CITY OF SAN ANTONIO

Re: Westover Valley Subdivision MDP # 762

The City Staff Development Review Committee has reviewed Westover Village Master Development Plan M.D.P. # 762. Please find enclosed a signed copy for your files. Your plan was accepted, however please note the following:

WESTOVER VALLEY SUBDIVISION

MASTER DEVELOPMENT PLAN

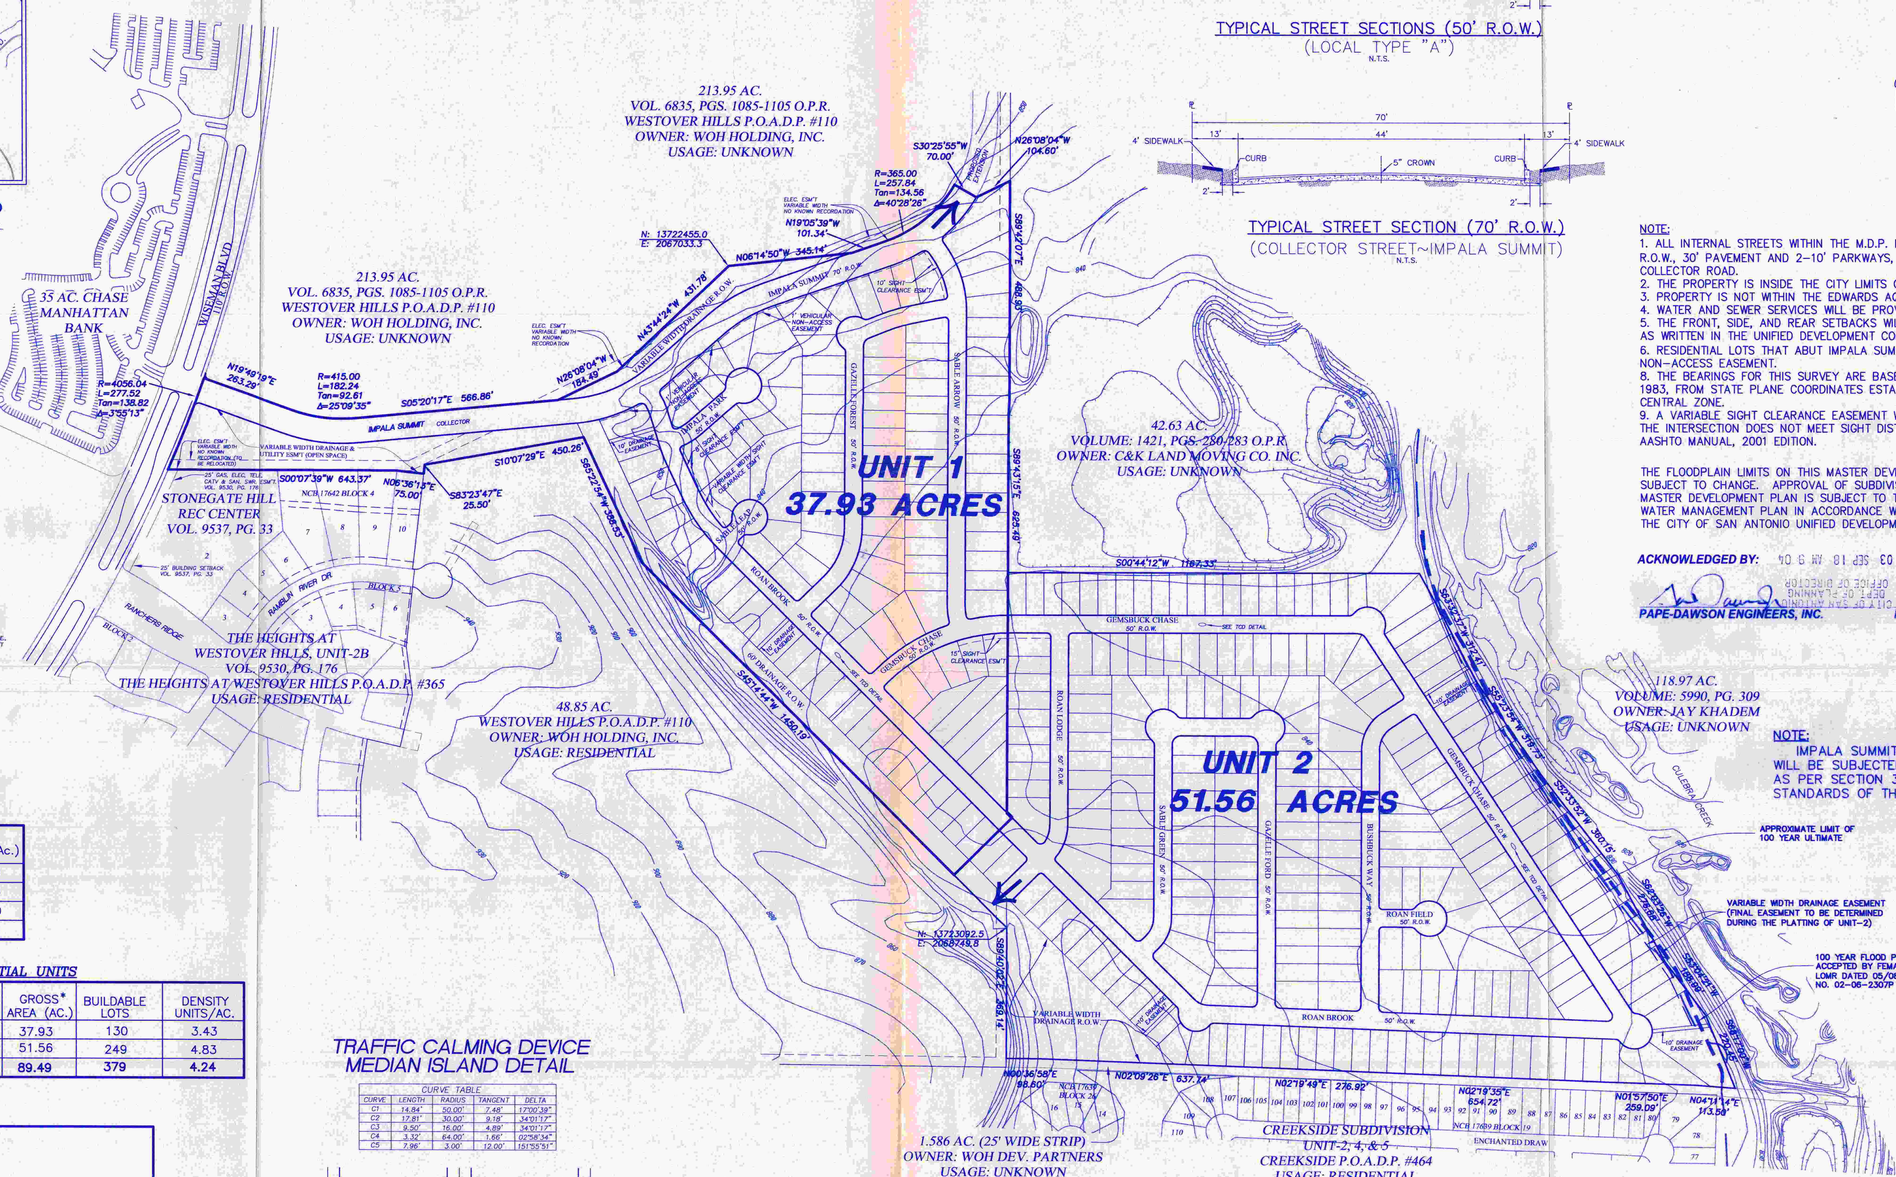
- In consideration of public safety and convenience, excessive grades by reason of topography should be avoided in street layouts and arrangements.

1. This includes such items as intersection sight distances, street design and pavement requirements, traffic calming, cul-de-sac requirements, knuckle requirements, and right-of-way requirements.

2. This property is proposed to composed to consist of 374 single family detached homes. Based on the 6th edition of the ITE Trip Generation Manual, this property is estimated to generate 381 peak hour trips. A new collector street will be provided at an existing median opening on Wiseman Blvd. extending to the north edge of the property which will eventually continue to Rogers Road. Two access points will be provided into the new collector street. A stub-out street will provide additional connectivity to the east portion of the property.

1. The existing median opening on eastbound Wiseman Blvd. shall be modified to provide a minimum of 153 feet of storage capacity.

2. The proposed collector will have a minimum of 70 ft. ROW with 44 ft. pavement and shall be extended from Wiseman Blvd to the northern portion of Unit One.

1. Westover Valley is a proposed subdivision of 377 residential units. Base on Section 35-503 of the UDC, the park dedication requirement for this development is 3.4 acres.

2. Prior to the recordation of the first plat filed under this Plan, a fee in-lieu of dedication in the amount of $36,706.50 is to be paid to the Parks and Recreation department prior to the recordation of the first plat filed under this plan.
